## Addendum No. 2

DATE:	Monday, June 24, 2019
PROJECT:	City of Pharr/PSJA Aquatic Facility
PROJECT NO:	971805/ 1819-35-510-C011-051
LOCATION:	3001 N. Cage Blvd., Pharr, Texas 78577
FROM:	Laura N. Warren, The Warren Group Architects, Inc.

S552

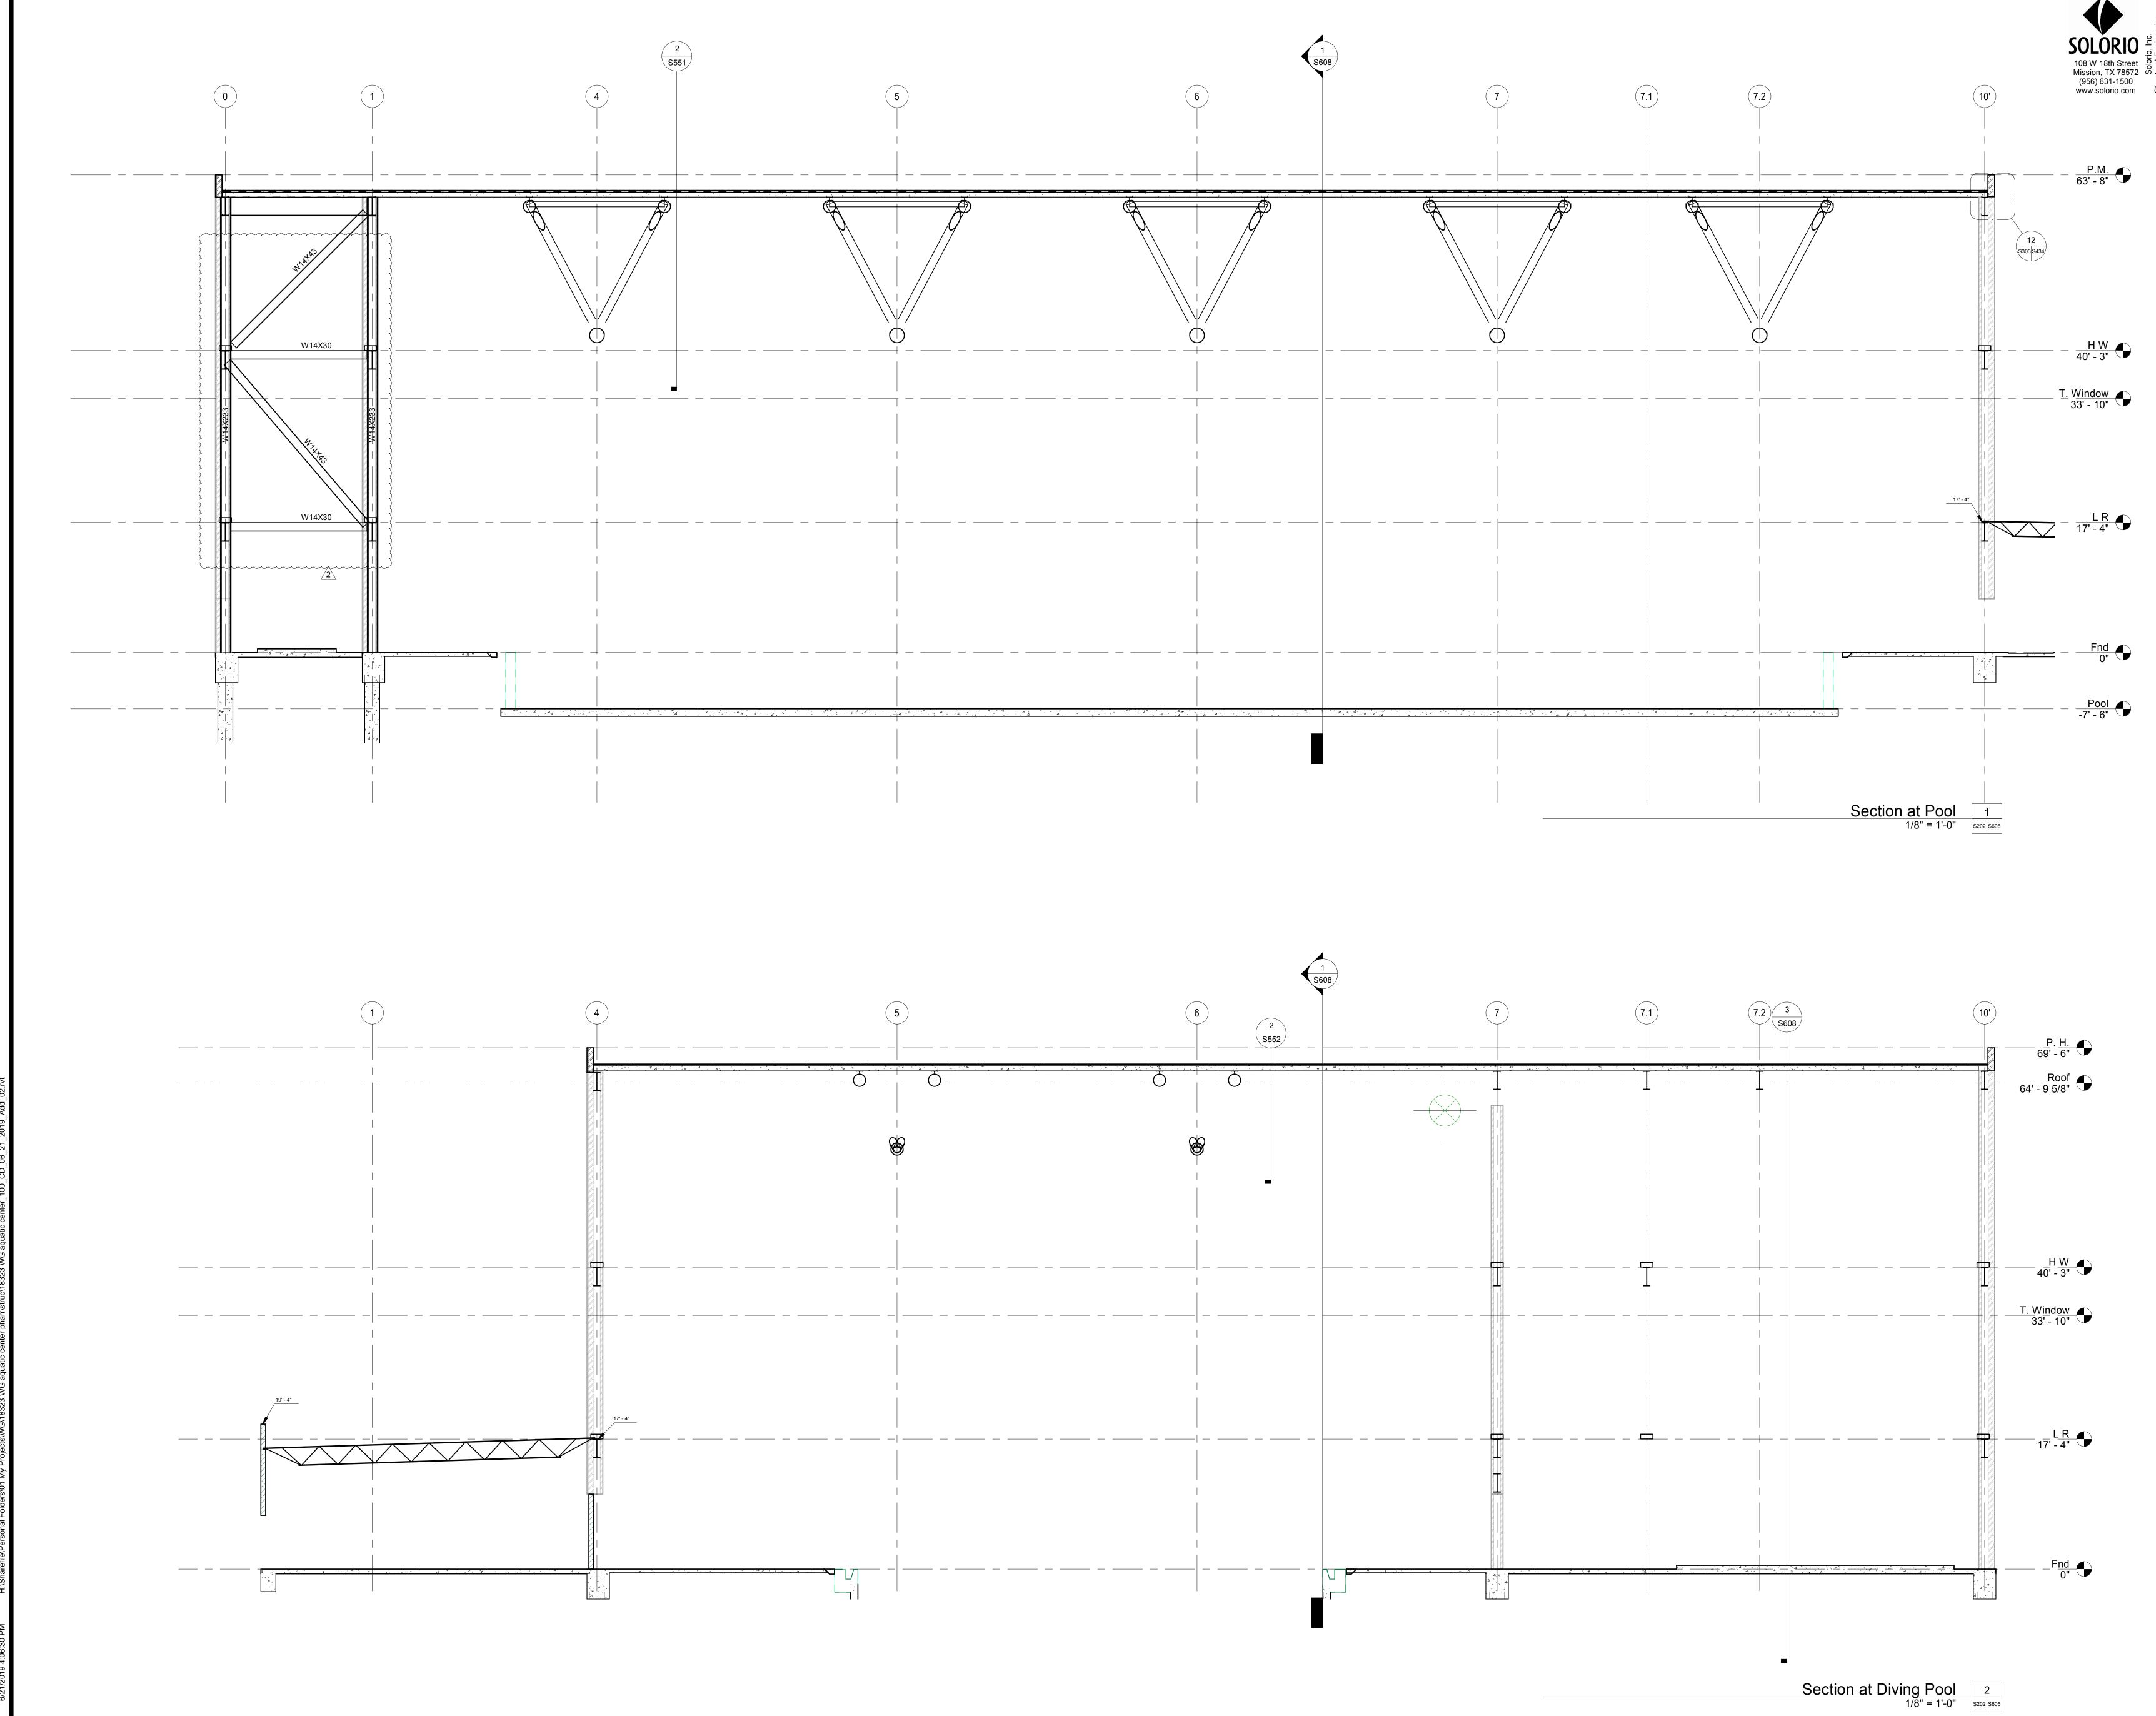
- Item No. 9: Refer to Construction Documents dated June 7, 2019. STRL Truss Details has additional information included. Refer to 30x42 sheet S552 dated 6/21/2019.
